CARVIN
12340 World Trade Drive
San Diego, CA 92128
(858) 487-1600
FAX 487-6629
DCM2, DCL AND DCX
FLAT PCB DESIGN
Dual TRACKER
DRAWN BY: GEORGE DREYER
DATE: 18 OCT2008
APPROVED:
DATE:
PCB NO: 30-02050
REV: J
ASSY. NO: 80-02050
REV:
REVISED BY: GEORGE DREYER
DATE: 16 JUNE 09

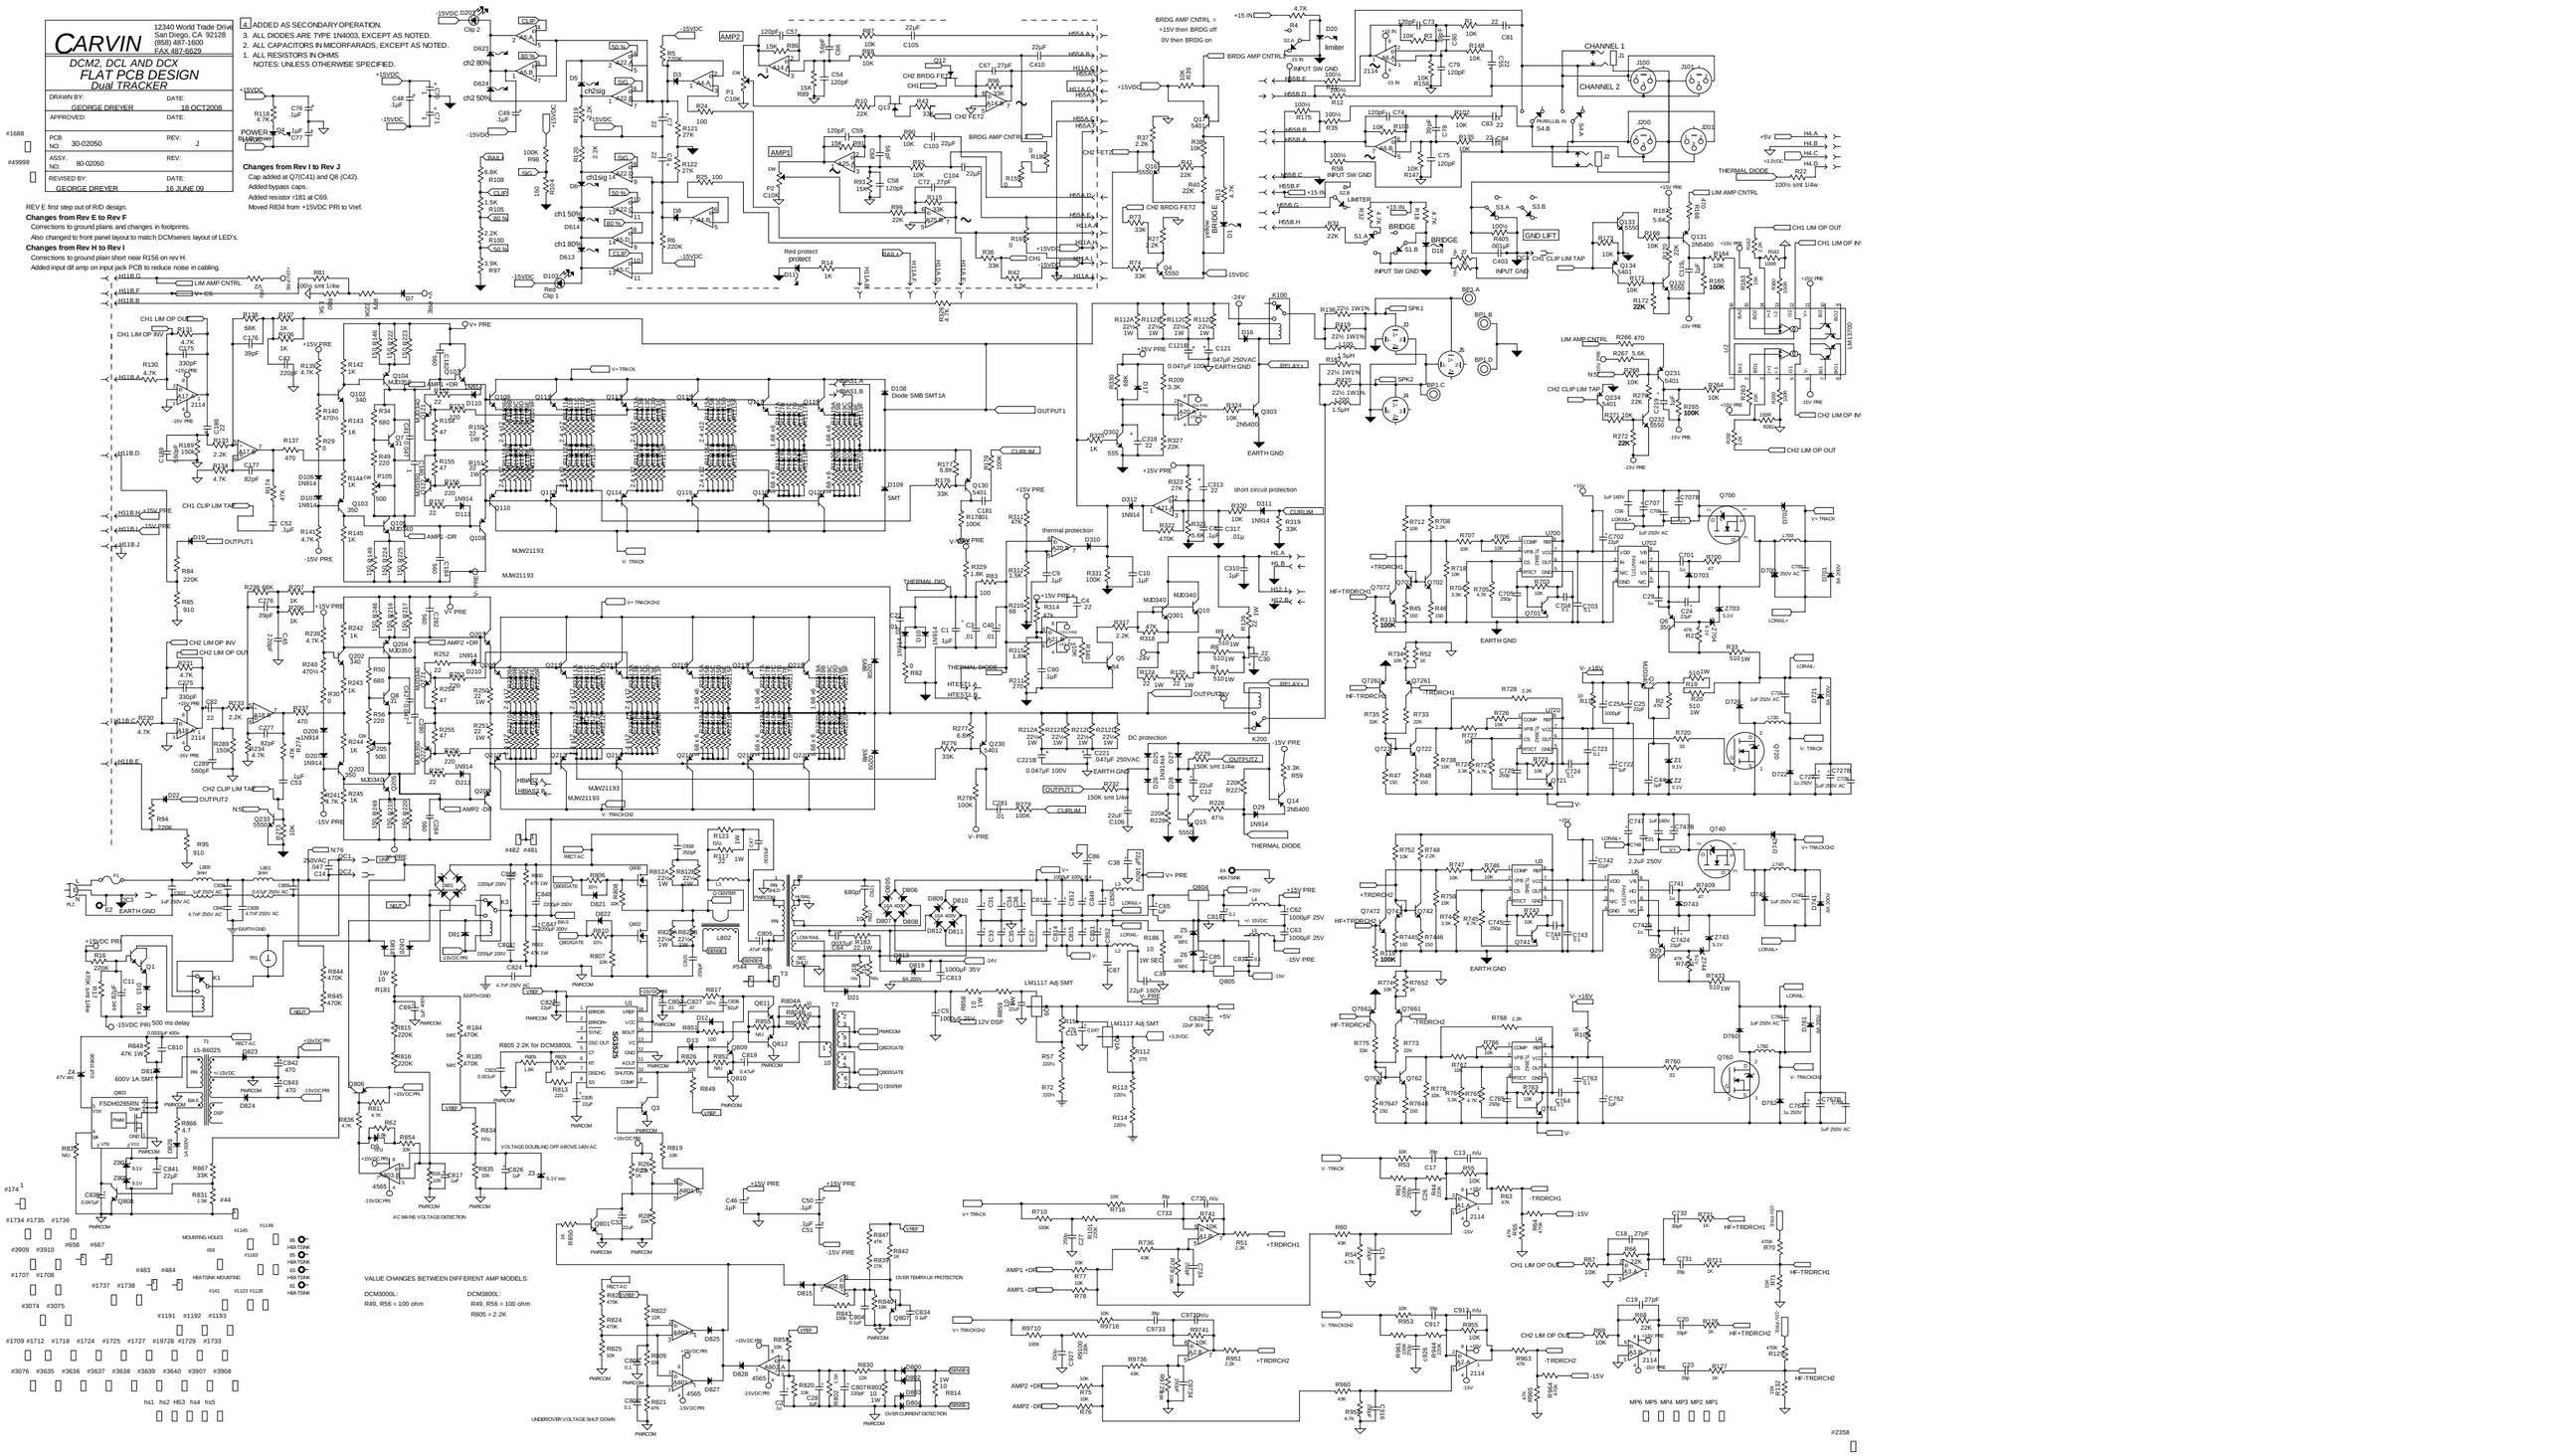
#1688
#49998
4. ADDED AS SECONDARY OPERATION.
3. ALL DIODES ARE TYPE 1N4003, EXCEPT AS NOTED.
2. ALL CAPACITORS IN MICORFARADS, EXCEPT AS NOTED.
1. ALL RESISTORS IN OHMS
NOTES: UNLESS OTHERWISE SPECIFIED.
Changes from Rev I to Rev J
Cap added at Q7(C41) and Q8 (C42).
Added bypass caps.
Added resistor r181 at C69.
Moved R834 from +15VDC PRI to Vref.
REV E first step out of R/D design.
Changes from Rev E to Rev F
Corrections to ground plains and changes in footprints.
Also changed to front panel layout to match DCMseries layout of LED's.
Changes from Rev H to Rev I
Corrections to ground plain short near R156 on rev H.
Added input dif amp on input jack PCB to reduce noise in cabling.
VALUE CHANGES BETWEEN DIFFERENT AMP MODELS:
DCM3000L:
R49, R56 = 100 ohm
DCM3800L:
R49, R56 = 100 ohm
R805 = 2.2K
